Access Compliance Report

Public Rights-of-Way

(Curb Ramps)

Intersection ID: 26100	Main Street: FAIRCHILD_LN	Cross Street: HOLLY_HILL_FARM_RD	Location: SW
ADA ID: 1F0452BA48C8	Ramp Type: PerpDiag	Initial Pass/Fail: Fail	Overall Compliance: No
Severity Score: 12.5			
Codes/Mitigation Info/Possible Solution		Field Measurements/Component Compliance

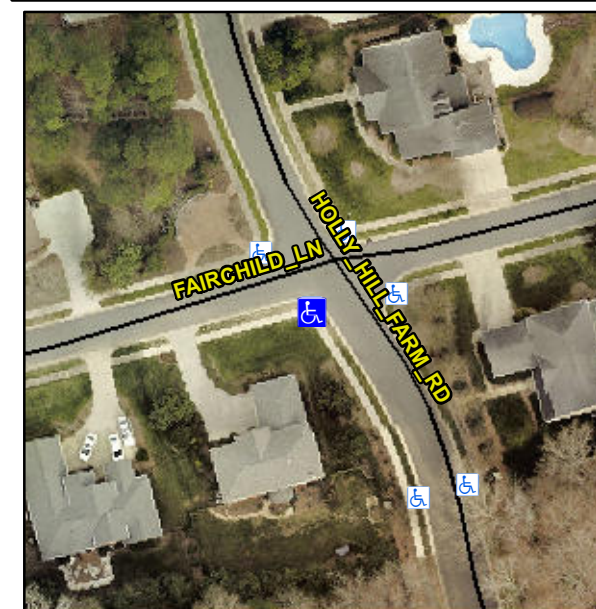
Compliance	Description	Data	Compliance	Description	Data
N/A	Ramp Length (in)	97.0	Yes	Ramp Slope (%)	7.0
Yes	Ramp Width (in)	51.0	No	Ramp XSlope (%)	5.3
N/A	Flare Type LT	N/A	N/A	Flare Type RT	N/A
N/A	Flare Slope LT (%)	N/A	N/A	Flare Slope RT (%)	N/A
N/A	Flare Traversable LT?	N/A	N/A	Flare Traversable RT?	N/A
N/A	Landing Length (in)	N/A	N/A	DWS Provided?	N/A
N/A	Landing Width (in)	N/A	N/A	DWS Contrast?	N/A
N/A	Landing Slope (%)	N/A	N/A	DWS Length (in)	N/A
N/A	Landing X Slope (%)	N/A	N/A	DWS Full Width?	N/A
N/A	Landing Curb? (Y/N)	N/A	N/A	DWS Offset (in)	N/A
N/A	Shared Landing?	N/A			
N/A	Gutter Ponding?	N/A	N/A	Gutter Slope (%)	N/A
N/A	Gutter Lip Ht (in)	N/A	N/A	Gutter X Slope (%)	N/A
N/A	Painted X Walk1?	No	N/A	Painted X Walk2?	No
	X Walk 1 Direction	To E		X Walk 2 Direction	To NW
N/A	X Walk 1 Width (in)	N/A	N/A	X Walk 2 Width (in)	N/A
	X Walk 1 Slope (%)	5.4		X Walk 2 Slope (%)	0.4
	X Walk 1 X Slope (%)	2.9		X Walk 2 X Slope (%)	3.5

N/A	Ramp inside XWalk1?	N/A	N/A	Ramp inside XWalk2?	N/A
	Road Slope (%)	1.9	N/A	Clear Space?	N/A
	Road X Slope (%)	5.2	N/A	Clear Space to XWalk (in)	N/A
N/A	Any Obstructions?	N/A	N/A	Storm Grate/Utility Hazard?	N/A
	Obstruction Type			Storm Grate/Utility Type	
		N/A			N/A
		Yes		Surface Condition? (G/P)	Good

Remove & Replace Curb Ramp With Two New Directional Ramps or Equivalent.
